SERVICE LETTER

No. 846

Piper Aircraft Corporation

Subject: Stabilator Assembly Lower Surface Rivet Inspection

BOTTOM VIEW OF LEFT STABILATOR SHOWN – RIGHT STABILATOR OPPOSITE

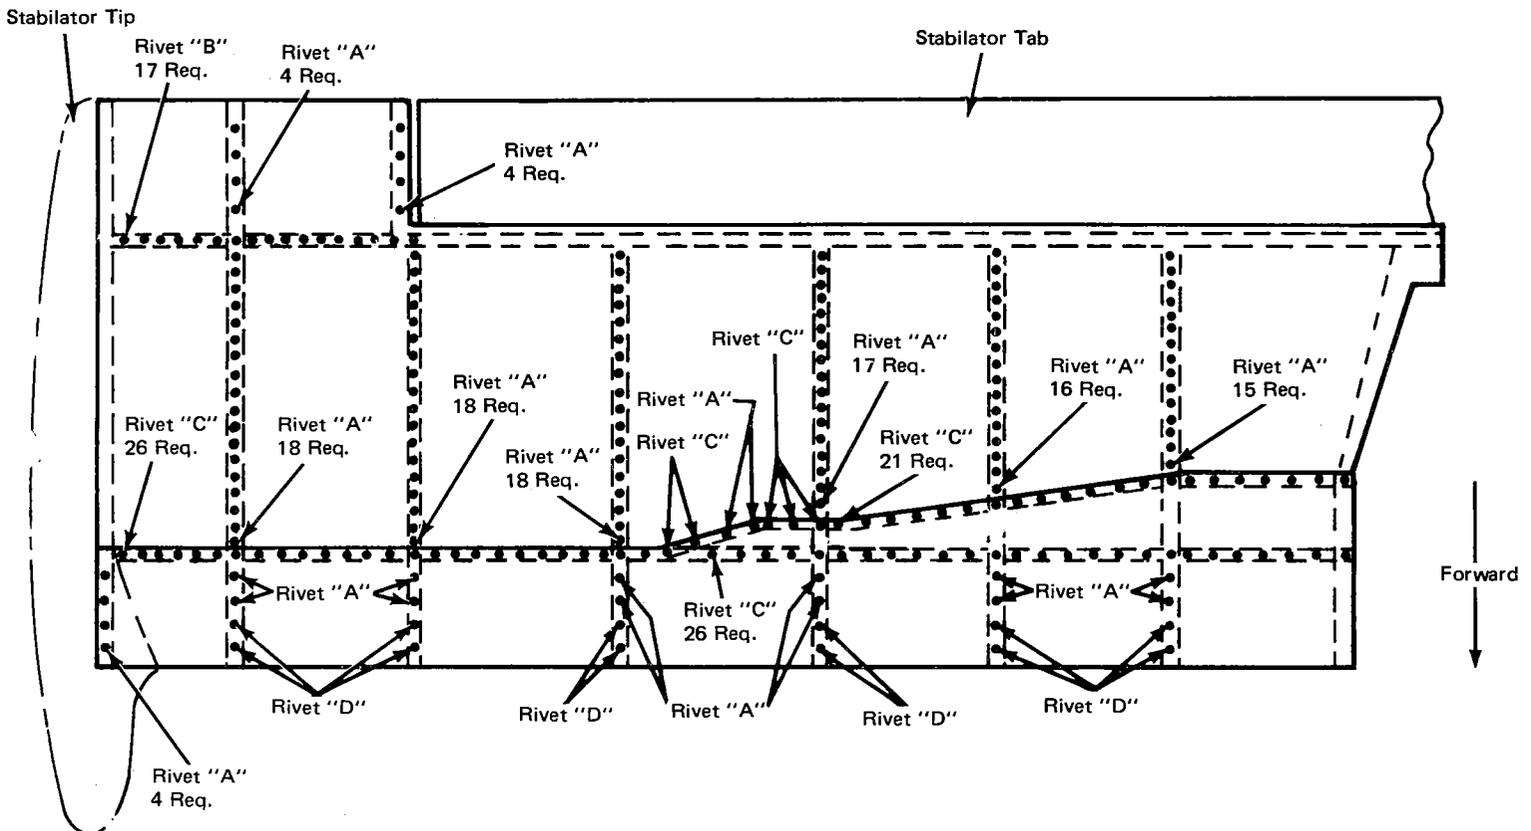
It has been brought to our attention that the blind rivets installed on the stabilator bottom skin panels on the above referenced aircraft are subject to loosening and/or working. This condition may be noted by the presence of dark streaks downstream of the rivet heads.

This Service Release contains instructions to inspect the lower surface of the stabilators referenced above for evidence of loose rivets, and to replace loose rivets, as required; replacement rivets specified on the attached sketch/instruction sheet are "Cherry Lock" and/or "Cherry Max" type.

1. Inspect the lower surface of the left and right stabilator assembly for evidence of loose rivets.
2. Any rivet(s) found to be loose must be replaced as follows. Do not replace rivets that are not loose.
 - a. Carefully grind head off any loose rivet(s).
 - b. Refer to sketch and table above and install the correct length cherry lock or cherry max rivet(s).
3. Make proper logbook entry of Service Letter compliance.

<u>RIVET</u>	<u>CHERRY LOCK</u>	<u>CHERRY MAX</u>
A	NAS1738B-4-1 (P/N 522 881)	CR3243-4-1 (P/N 522 906)
B	NAS1738B-4-2 (P/N 522 882)	CR3243-4-2 (P/N 522 655)
C	NAS1738B-4-3 (P/N 522 883)	CR3243-4-3 (P/N 522 656)
D	NAS1739B-4-1 (P/N 522 871)	CR3242-4-1 (P/N 522 654)
